Access Compliance Report

Public Rights-of-Way

(Curb Ramps)

Intersection ID: 12365	Main Street: E_10TH_ST	Cross Street: N_ALEXANDER_ST	Location: S
ADA ID: 85C83C082847	Ramp Type: PerpDiag	Initial Pass/Fail: Fail	Overall Compliance: No
			Severity Score: 33.75

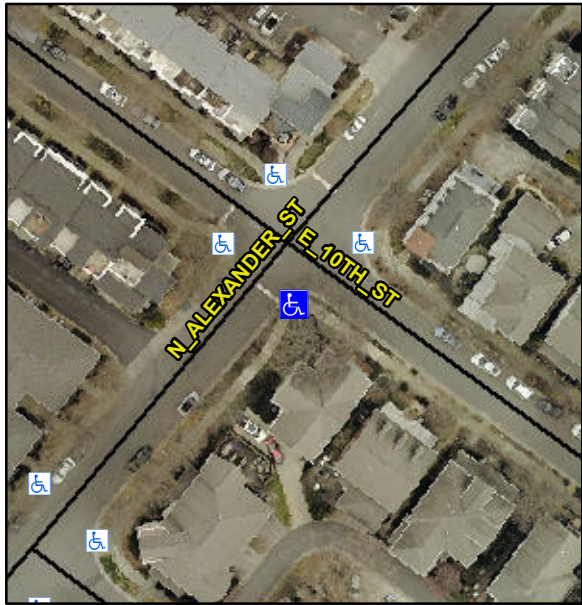
Codes/Mitigation Info/Possible Solution			Field Measurements/Component Compliance					
 Street 1 Name E 10TH ST Stop Condition-Street 2 StopSign Street 2 Name N ALEXANDER ST Stop Condition-Street 1 None	Possible Solutions:		Compliance	Description	Data	Compliance	Description	Data
	Remove & Replace Curb Ramp With Two New Directional Ramps or Equivalent.		N/A	Ramp Length (in)	29.0	Yes	Ramp Slope (%)	7.3
			No	Ramp Width (in)	39.0	No	Ramp XSlope (%)	9.8
			N/A	Flare Type LT	N/A	N/A	Flare Type RT	N/A
			N/A	Flare Slope LT (%)	N/A	N/A	Flare Slope RT (%)	N/A
			N/A	Flare Traversable LT?	N/A	N/A	Flare Traversable RT?	N/A
			N/A	Landing Length (in)	N/A	N/A	DWS Provided?	N/A
			N/A	Landing Width (in)	N/A	N/A	DWS Contrast?	N/A
			N/A	Landing Slope (%)	N/A	N/A	DWS Length (in)	N/A
			N/A	Landing X Slope (%)	N/A	N/A	DWS Full Width?	N/A
Surveyor Notes:		N/A	N/A	Landing Curb? (Y/N)	N/A	N/A	DWS Offset (in)	N/A
PROW/ADA:		Not Found, R304.5.1, R304.5.3	N/A	Shared Landing?	N/A

N/A	Gutter Ponding?	N/A	N/A	Gutter Slope (%)	N/A
			N/A	Gutter Lip Ht (in)	N/A	N/A	Gutter X Slope (%)	N/A
			N/A	Painted X Walk1?	No	N/A	Painted X Walk2?	No
				X Walk 1 Direction	To NE		X Walk 2 Direction	To NW
			N/A	X Walk 1 Width (in)	N/A	N/A	X Walk 2 Width (in)	N/A
				X Walk 1 Slope (%)	0.8		X Walk 2 Slope (%)	5.6
				X Walk 1 X Slope (%)	6.6		X Walk 2 X Slope (%)	5.0
			N/A	Ramp inside XWalk1?	N/A	N/A	Ramp inside XWalk2?	N/A
				Road Slope (%)	8.9	N/A	Clear Space?	N/A
				Road X Slope (%)	2.8	N/A	Clear Space to XWalk (in)	N/A
			N/A	Any Obstructions?	N/A	N/A	Storm Grate/Utility Hazard?	N/A
				Obstruction Type			Storm Grate/Utility Type	
						N/A		N/A
						Yes	Surface Condition? (G/P)	Good
Total Cost:		\$ 3200.00
